Manitowoc® **Parts & Service Communicator**

Subject: Manitowoc Product Improvement Program Recall of Hanning Water Pump Model DPO 25-216 in EC Model Machines

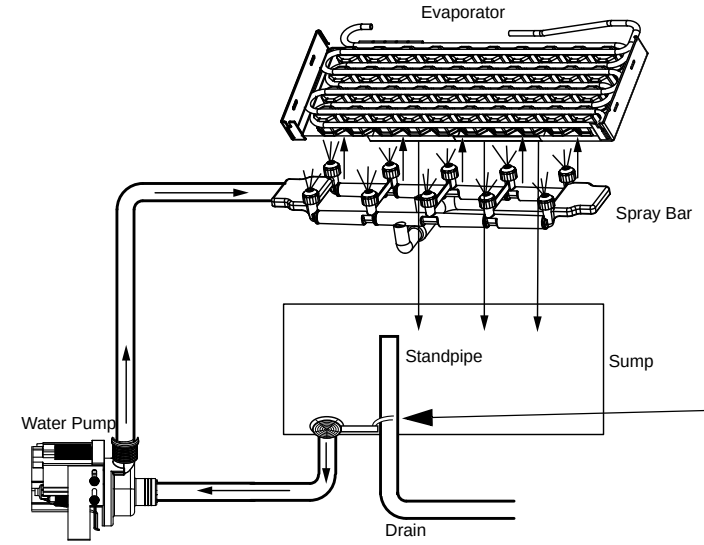
The recalled water pumps are identified by an I.D. tag on the water pump which contains the following information (as depicted in the accompanying photographs).

Recalled pump:

Pump Manufacturer: Hanning Electro-Werke

Model Number: DPO 25-216

Voltage: 220 - 240 V Frequency: 50 Hz

Recalled Hanning Electro-Werke Pump

Replacement pump which complies with Manitowoc's specifications is Model DPO 25-258:

Replacement Hanning Electro-Werke Pump

Water Pump Inlet Strainer
EC20/30/40/50 Only

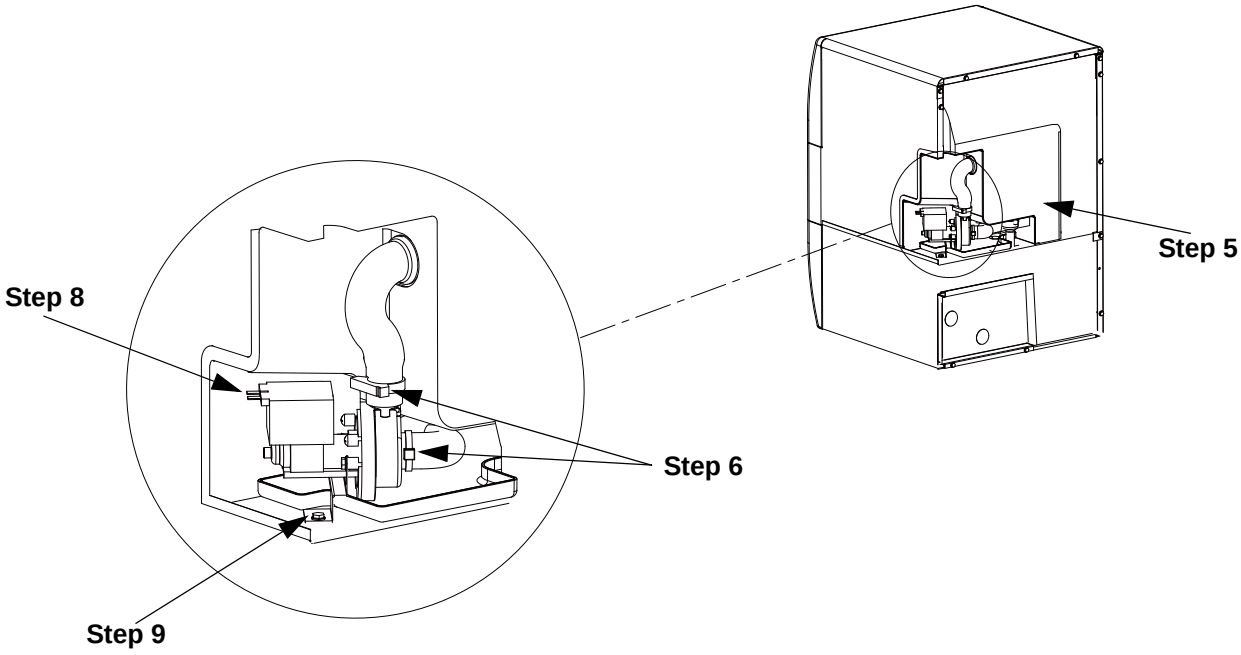
Step 3

1. Disconnect power, lock out/tag out the ice machine.
2. Remove the standpipe in the sump to drain water.
3. *EC20/30/40/50 Only:* Snap the provided strainer onto the standpipe.
4. Re-install the standpipe with strainer attached. The strainer must cover the drain that leads to the water pump to prevent debris from entering the pump.
5. Remove the back panel to access the pump.
6. Disconnect hose clamps & remove hoses.
7. Disconnect electrical terminals.
8. Disconnect mount bracket screw and remove pump.
9. Install & mount new pump.
10. Connect electrical terminals.
11. Use a container to refill sump with water.
12. Test run the ice machine.
